# PRELIMINARY INFORMATION SHEET (BRIDGE)

PROJECT NAME: **WAITSFIELD**  
 PROJECT NUMBER: **BF 013-4(39)**  
 FILE NAME: z12b136quantity.xlsm PLOT DATE: 10/13/2015  
 PROJECT LEADER: R.YOUNG DRAWN BY: S. MERKWAN  
 DESIGNED BY: VTRANS/D.KULL CHECKED BY: T.KENDRICK  
**PRELIMINARY INFORMATION SHEET 1** SHEET 2 OF 69

REV	DATE	DESCRIPTION
	10/13/2015	NOTE REVISIONS

PROJECT NAME:	WAITSFIELD	FILE NAME:	z12b136typ.dgn	PLOT DATE:	10/13/2015
PROJECT NUMBER:	BRF 013-4(39)	PROJECT LEADER:	R. YOUNG	DRAWN BY:	S. MERKWAN
		DESIGNED BY:	D. KULL	CHECKED BY:	T. KENDRICK
		TYPICAL SECTIONS SHEET 1		SHEET	9 OF 69

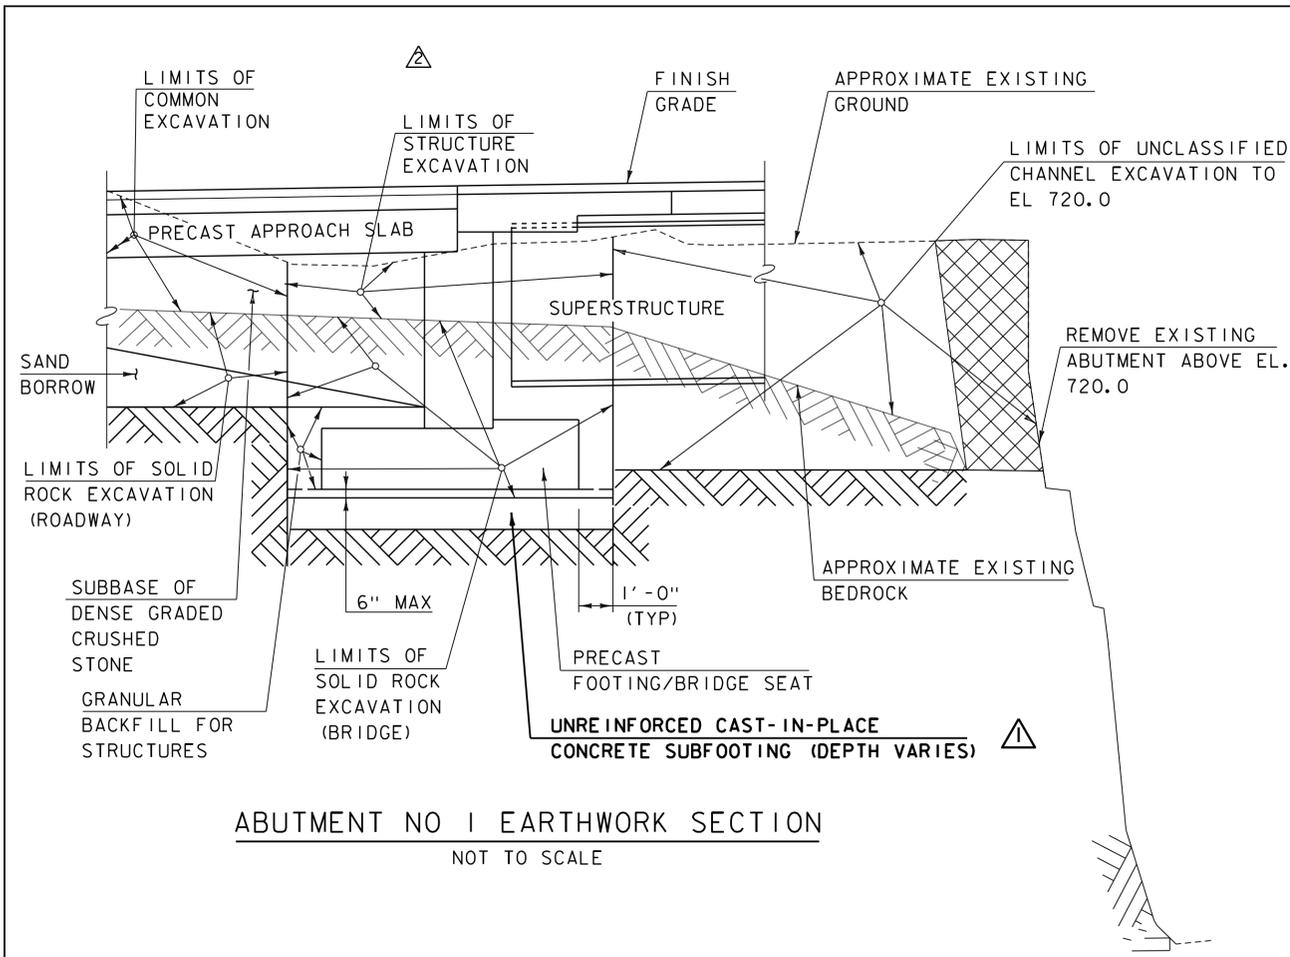
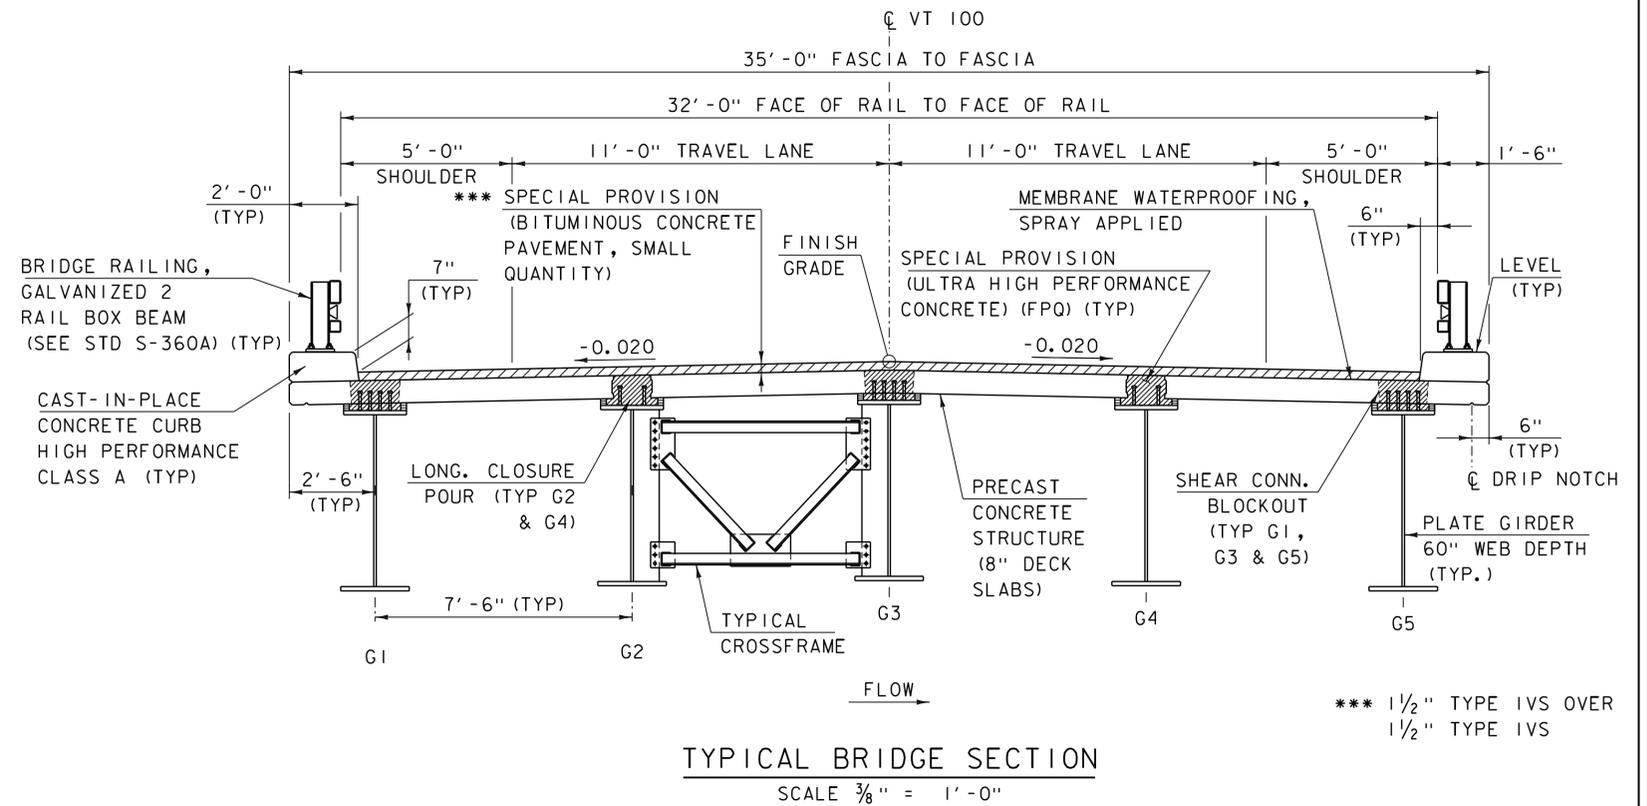
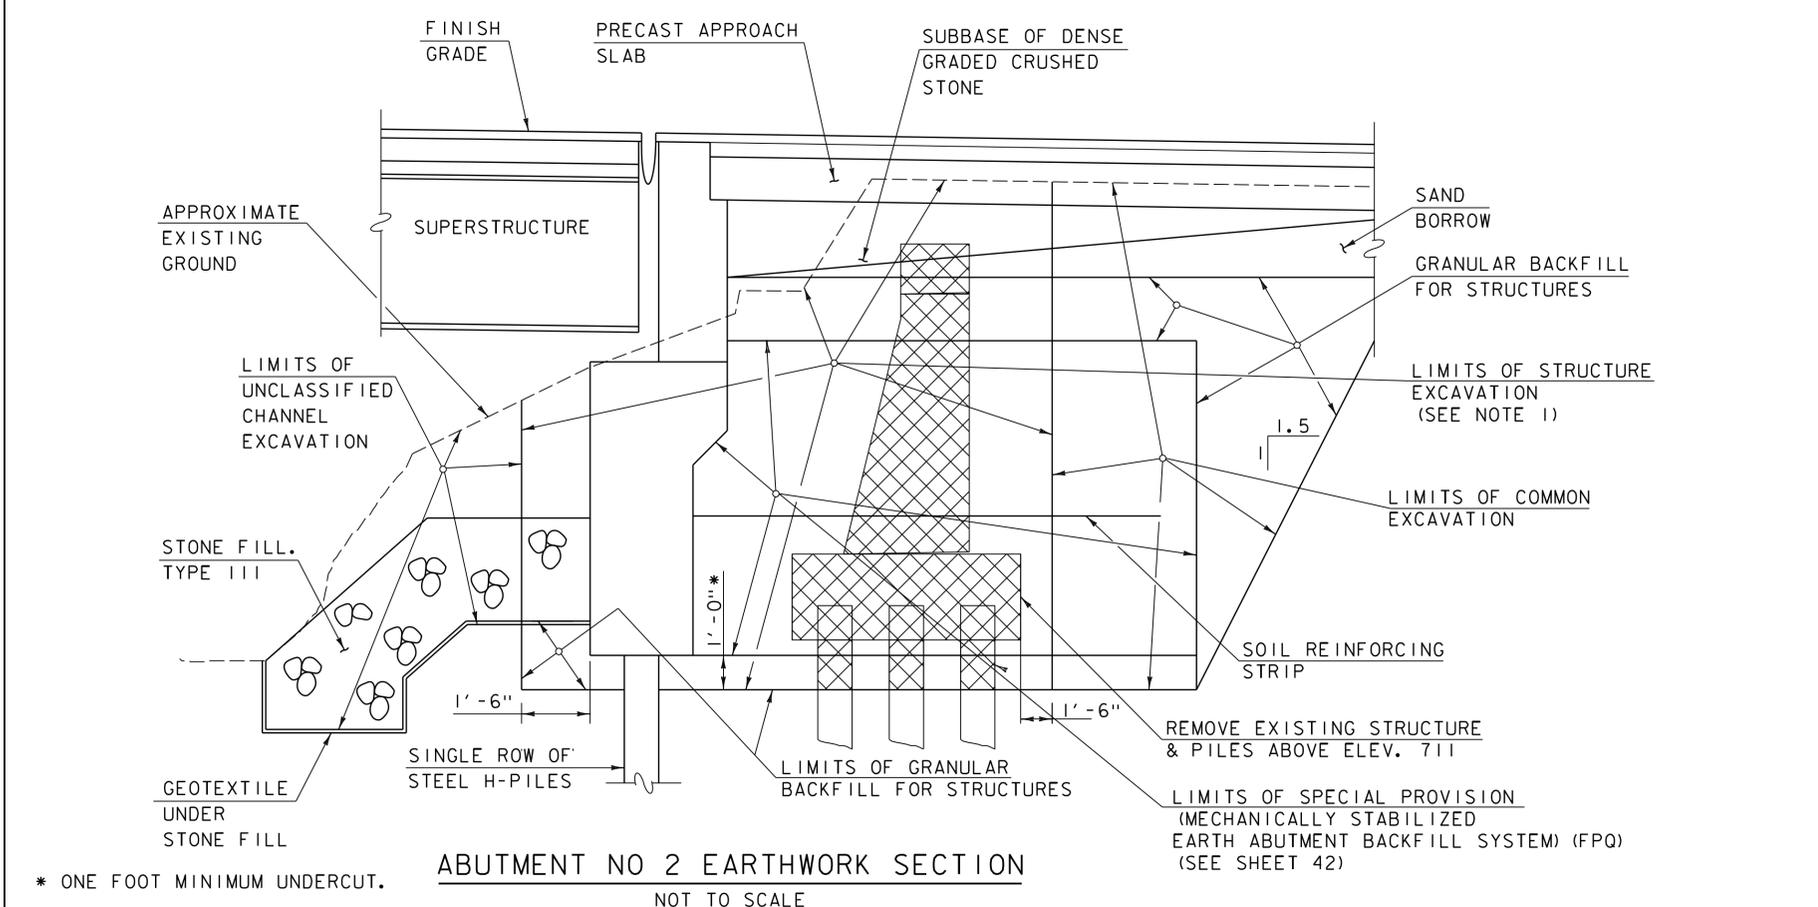
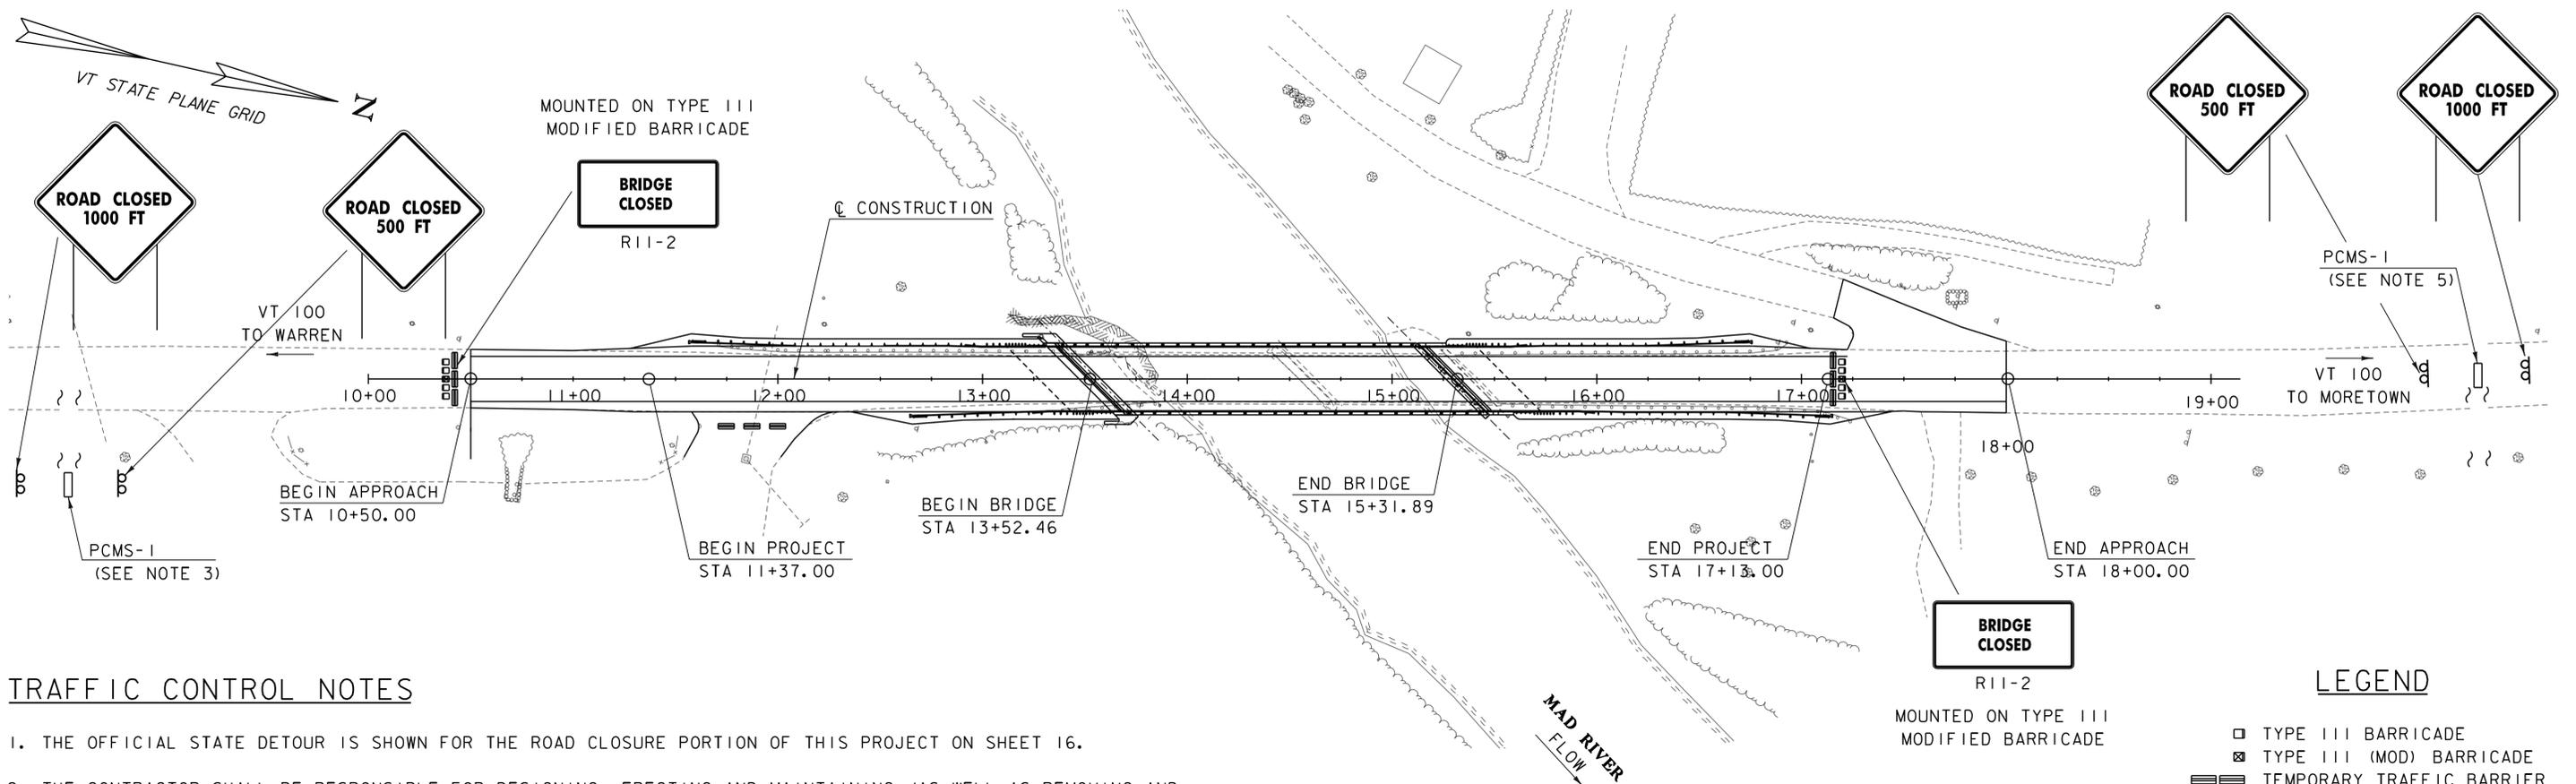
REV	DATE	DESCRIPTION
△	10/13/2015	SUBFOOTING REVISION
△	10/13/2015	DRILLING AND BLASTING NOTE REMOVED

PROJECT NAME:	WAITSFIELD
PROJECT NUMBER:	BRF 013-4(39)
FILE NAME:	z12b136sup_dtlis.dgn
PROJECT LEADER:	R.YOUNG
DESIGNED BY:	D.KULL
MISCELLANEOUS DECK DETAILS I	
PLOT DATE:	10/13/2015
DRAWN BY:	S.MERKWAN
CHECKED BY:	T.KENDRICK
SHEET	27 OF 69

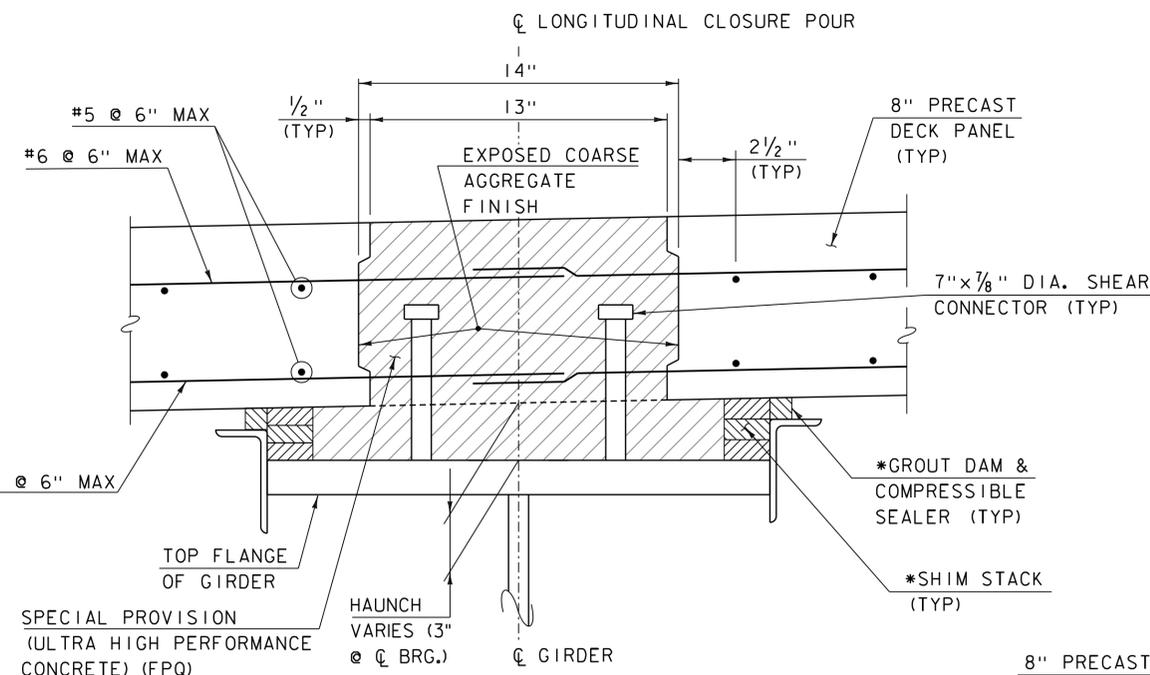
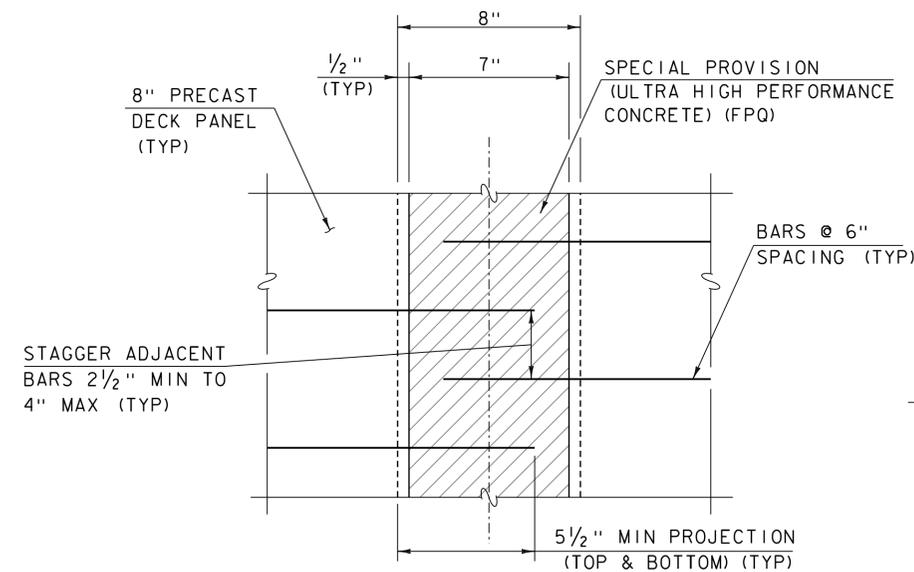
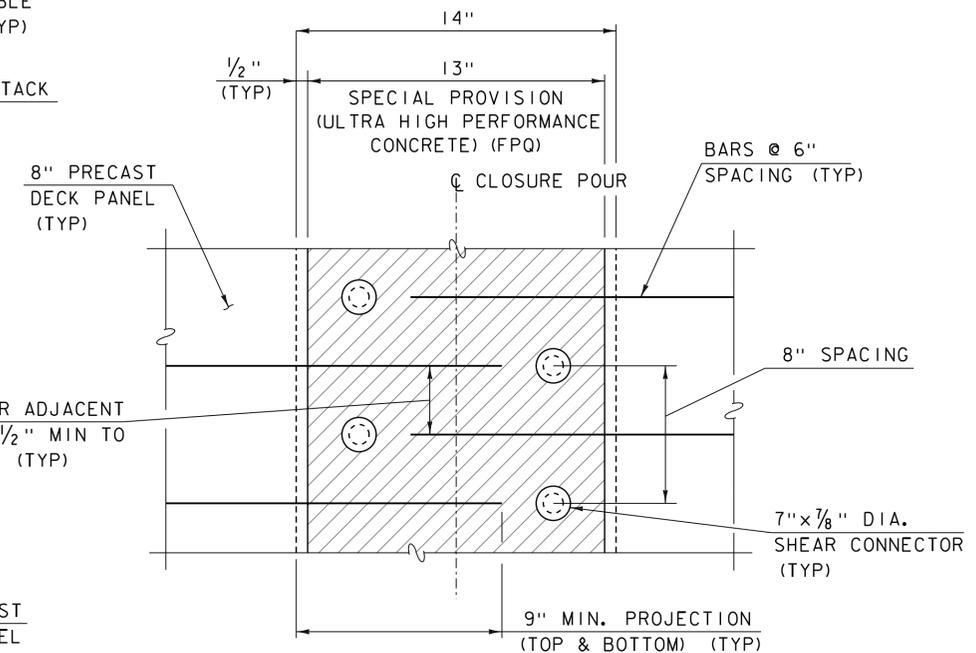
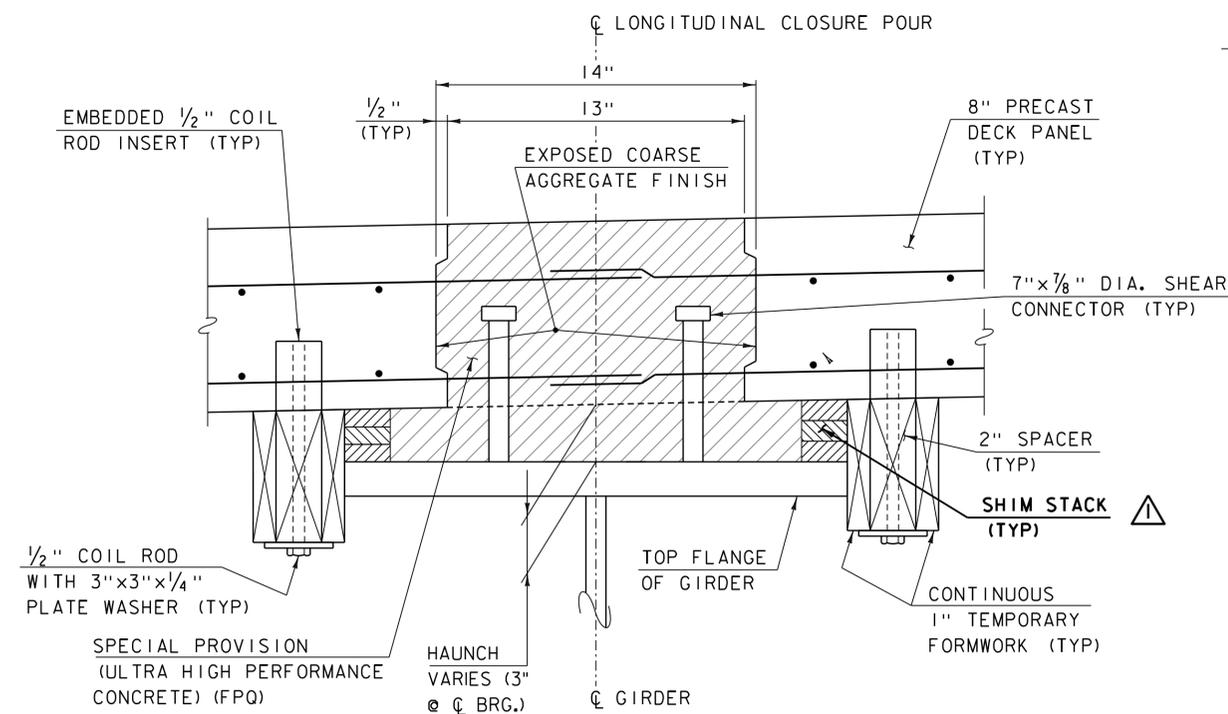
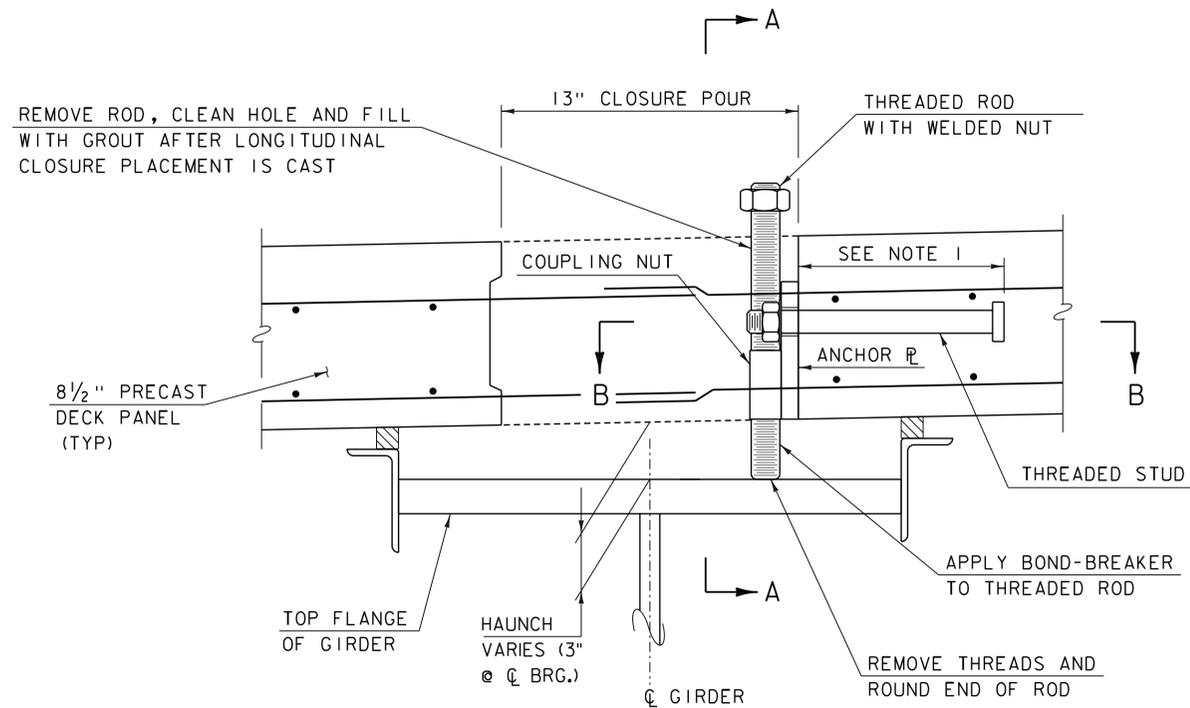
REV	DATE	DESCRIPTION
△	10/13/2015	SHIM STACK NOTE REVISION

\*THE SHIM STACK DECK SUPPORT SYSTEM & TEMPORARY GROUT DAM SHOWN IS CONCEPTUAL. THE CONTRACTOR'S PROPOSED SYSTEM SHALL BE SUBMITTED TO THE ENGINEER FOR REVIEW PER SECTION 540. OF THE STANDARD SPECIFICATIONS
